SUBJECT: BYRON STATION, UNITS 1 AND 2  
FOLLOW UP INSPECTION OF AN UNRESOLVED ITEM (URI)  
05000454/2008008; 05000455/2008008

Report Nos: 05000454/2008008; 05000455/2008008

Facility: Byron Station, Units 1 and 2

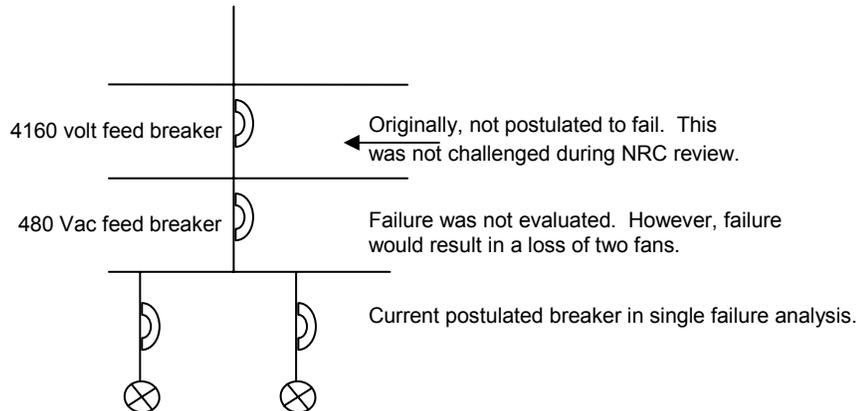
During the 2005 NRC safety systems design and performance capability inspection, the inspectors noted that in Technical Specification (TS) Amendment No. 95 for Byron Station (changes to the ultimate heat sink to support steam generator replacement), the most limiting single failure evaluated was the failure of active breakers or switches in the 480 Vac service water cooling towers (SXCT) bus which resulted in the failure of one service water cooling tower fan. The inspectors noted that the licensee did not address the 480 Vac feed breakers between the 4160/480 Vac transformer and bus 131Z (for example). The inspectors also noted that a single failure of either of the breakers would de-energize the bus and result in a loss of two service water cooling tower fans. See below for an illustration of the configuration.

The licensee disagreed, stating the breakers were normally closed and therefore, a passive failure need not be considered.

The issue was unresolved pending determination on whether the loss of the 4160 feed breaker should have been considered as the single failure.

Subsequent to the initiation of the URI, the inspectors held several discussions with the Electrical Branch in NRR and the Office of the General Counsel. The inspectors concluded that although Amendment No. 95 did not adequately distinguish single failure of electrical components (active vs passive), the failure of these feed breaker should have been considered in the licensee's analyses. As defined in 10 CFR Part 50, Appendix A:

Consistent with the definition of a single failure presented in 10 CFR Part 50, Appendix A, and General Design Criterion 44, the spurious failure/opening of the 4160 volt or 480 Vac should have been considered a valid single failure and assessed. In reviewing the licensee's Amendment No. 95, the NRC did not evaluate the potential for a passive failure of the electrical breakers even though passive failures were required to be evaluated under 10 CFR Part 50, Appendix A.

The inspectors and members of the Electrical Branch in NRR discussed the conclusions and the need to be in compliance with the licensee. The licensee initiated corrective actions 00711704 and 663350. To compensate for the nonconforming condition, the licensee continued implementing an administrative control to allow only one fan out of service (OOS), compared to two allowed by TS. By allowing only one fan OOS, the licensee maintains the required five fans needed to mitigate their design basis accident (LOCA concurrent with LOOP in one unit and LOOP in the other unit), assuming the remaining two are lost due to the single failure of the breakers.

In addition, the licensee plans to reanalyze their design basis which may require a TS change to increase the number of UHS fans required to be operable from six to seven. Consequently, the licensee invoked the provisions of NRC Administrative Letter (AL) 98-10, "Dispositioning of Technical Specifications That Are Insufficient to Assure Plant Safety" until such time the TS are revised or an engineering analysis demonstrates six fans are still acceptable for operability.
